June 26, 2020  
Project No.: 19125

Regarding: Daniels Sand Pit 2, Permit No. M-1973-007-SG  
Response to TR-09 Second Adequacy Review

In response to Timothy Cazier's April 14, 2020 Technical Revision (TR-09) Second Adequacy Review, this letter provides responses to DRMS comments. Mr. Cazier's comments pertain to a letter dated March 30, 2020 from Lithos Engineering to Aggregate Industries.

Figure 2.1 Geometry and Material Properties for the Fountain Mutual Ditch Above the New Wash Fines Pond

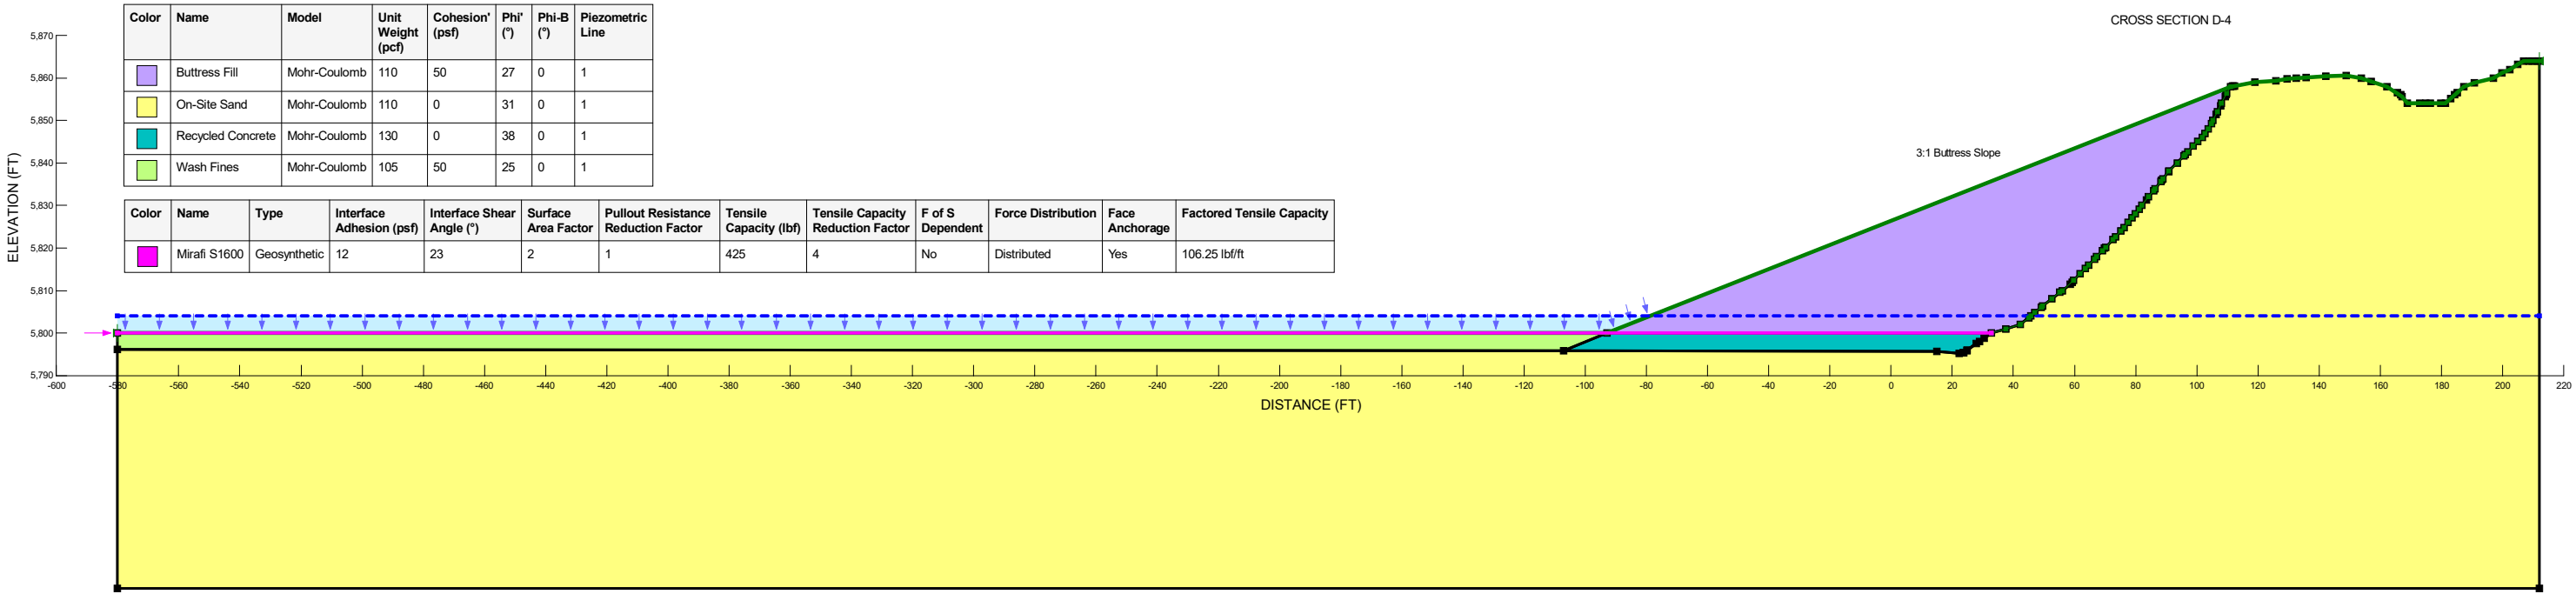
**Comment a)** *The geotextile is a potential slip plain and is not modeled in the Slope/W stability analysis. Please add this layer in the model with appropriate friction values for the geotextile or provide justification for why the geotextile is not addressed.*

**Response:** Correct, we are aware of the potential weakened slip plane. A geotextile layer was added to the model, the friction angle between the geotextile and soil interface was obtained from the Fundamentals of Geotechnical Engineering book authored by Das and Designing with Geosynthetics book authored by Koerner. Nonwoven needle punched geotextiles have higher interface friction compared to woven or heat bonded geotextiles. A Slope/W analysis was performed with the geotextile which resulted in a Factor of Safety (FOS) of 3.8. Slope geometry and geotechnical parameters used in the analysis are shown in Figure 2.1. Figure 2.2 presents the critical failure surfaces and calculated FOS

Figure 3.1 Analysis Results

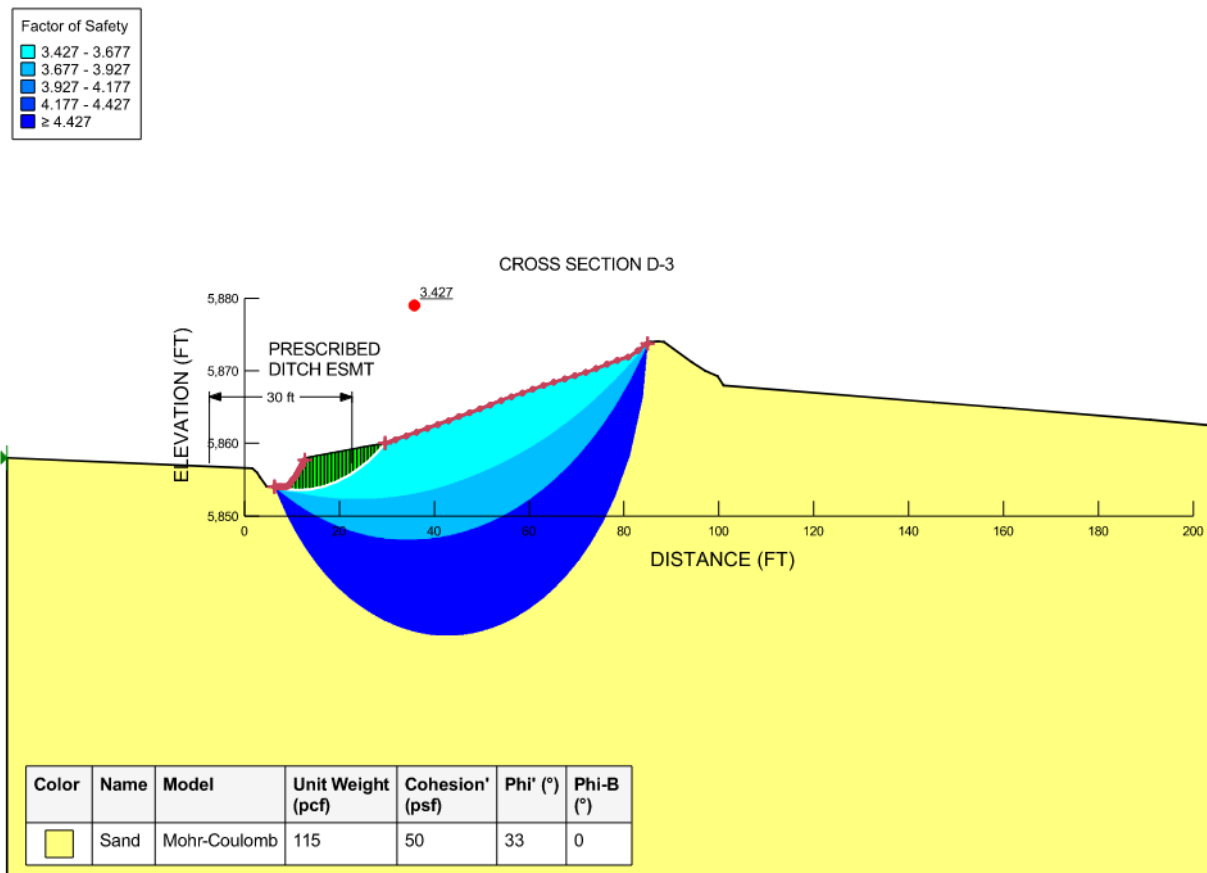
**Comment:** *The response is not adequate. Additional clarification is required. The DRMS accepts the differentiation between effective stress and total stress, but that does not explain why effective stress was used for section D-3 and total stress for the other three sections. Furthermore, the argument implies the Factor of Safety would be lower for section D-2 if effective stress was used. Please provide a rationale explaining the different approaches and what the factor of safety would be for section D-2 if effective stress was used.*

For the case of a free draining sand, total stress and effective stress analyses will have the same result because there is no buildup of excess pore pressures. To be consistent with the other sections, cross section D-3 was reanalyzed and determined to have an acceptable factor of safety of 3.4 as shown in Figure 3.1.
